AGENDA
HISTORIC PRESERVATION BOARD
Lakeland Electric Building, Conference Rooms 1A & 1B
July 27, 2023 8:30 A.M.

AGENDA
DESIGN REVIEW COMMITTEE
Lakeland Electric Building, Conference Rooms 1A & 1B
July 27, 2023
immediately following the Historic Preservation Board Meeting

- D. [HPB23-135 – 127 W. Belmar Street](#) – Final Approval requested for the new construction of a single-family house on the subject property. Owner: Scott and Tonya Strausser. Applicant: Mr. Ernie West, Sadler Homes.

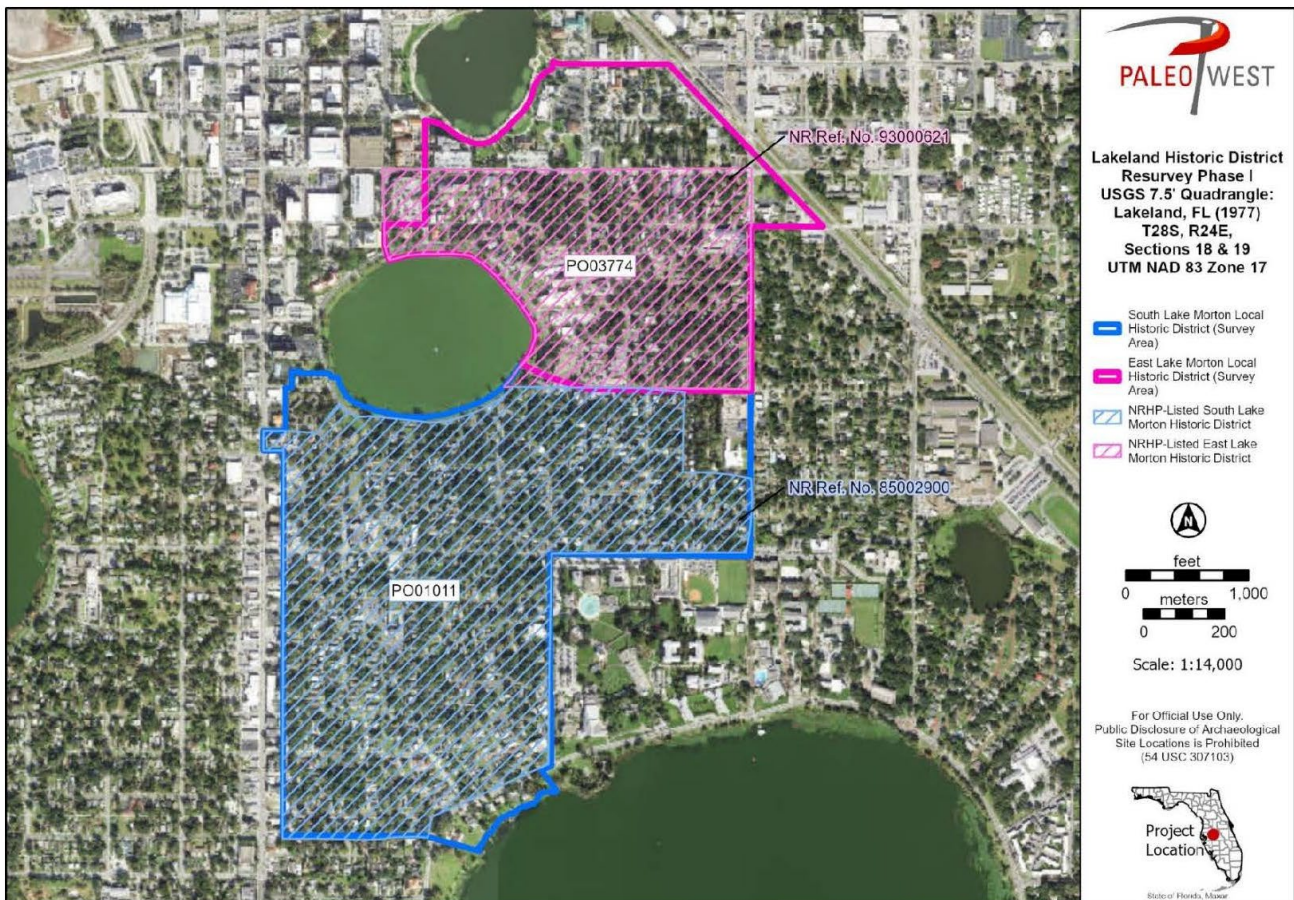
- Pursue boundary amendments to the NRHP-listed East and South Lake Morton Historic District boundaries to match the locally listed boundaries:
 - In the East Lake Morton Historic District, adjust the northern boundary to match the local historic district boundary.
 - In the South Lake Morton Historic District, adjust northeastern, northwest, and southern district boundaries to match the local historic district boundary.

Staff agrees with these recommendations.

FRONT ELEVATION
SCALE: 1/4" = 1'-0"

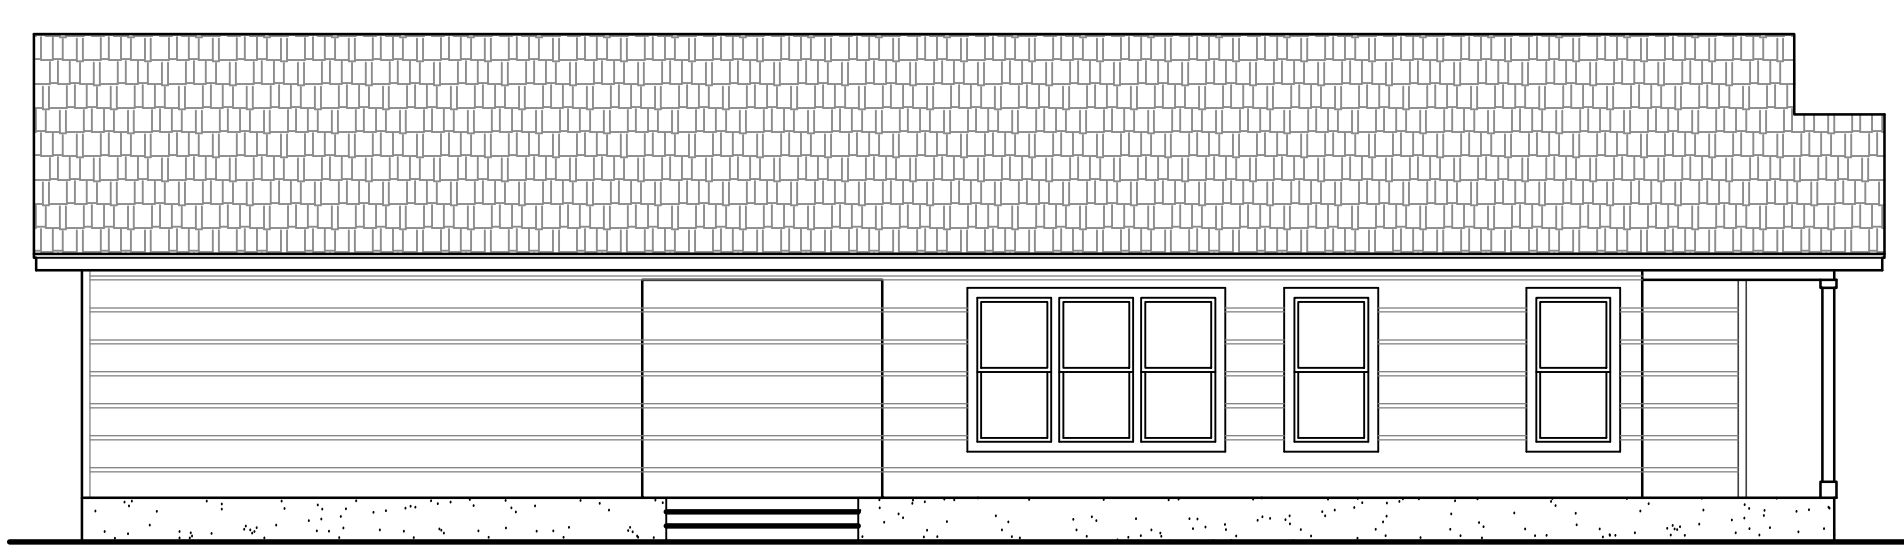
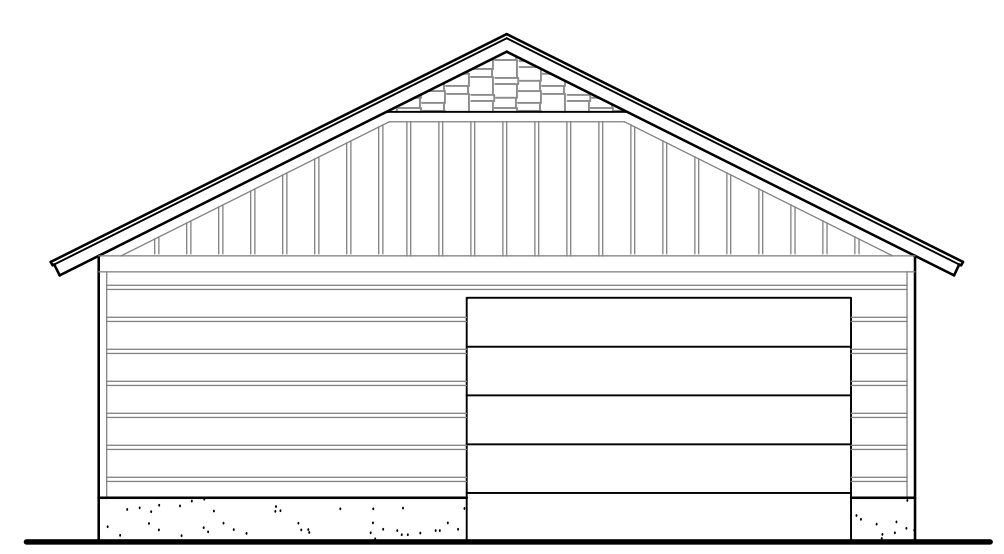
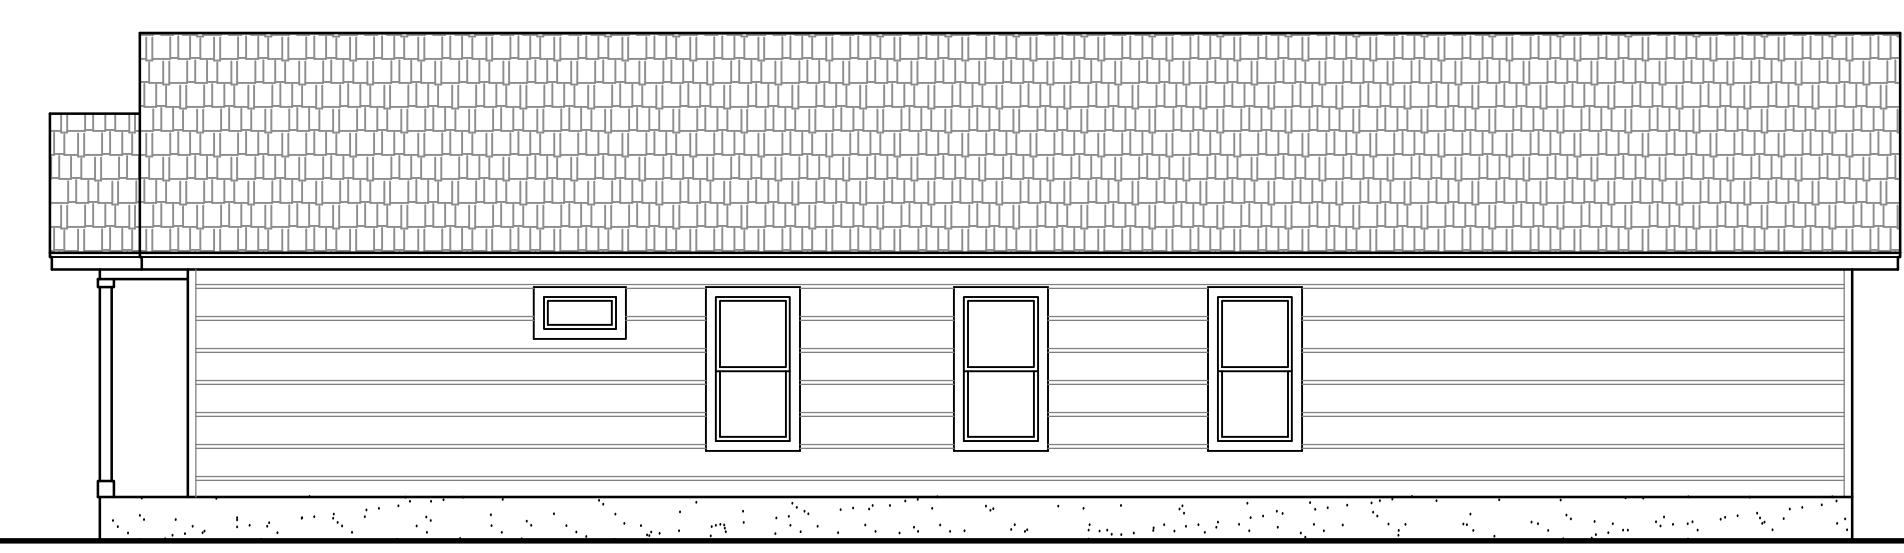
Staff finds that the proposed materials are consistent with residences in the surrounding neighborhood and the Design Guidelines. The design of the house displays a neo-traditional style that is compatible with the architectural character of the District. Features such as the front-gabled porch supported by square columns with simple capitals and bases, lap siding with board-and batten and shingle siding in gables, windows with a one-over-one lite configuration and a three-quarter lite double front door are consistent with historical architectural styles found in the neighborhood, as well as the Design Guidelines.

Finally, the proposed placement of the house on the lot is consistent with the Design Guidelines and Urban Neighborhood Standards in terms of orientation, building setbacks, and porch depth. The front yard building setback, at 15 feet, is the minimum required by the Code and is compatible with the houses on either side of the subject property; 205 W. Belmar Street to the west of the subject property is setback approximately 11 feet from the property line and 121 W. Belmar Street to the east of the subject property is setback approximately 12 feet from the property line.

1. Windows shall comply with the following requirements:
 - a. Windows must be recessed to provide a shadow line and not installed flush to the exterior wall surface.
 - b. Windows also must include historically appropriate trim, including header, sill, and apron.
2. Submittal of an exterior paint palette.
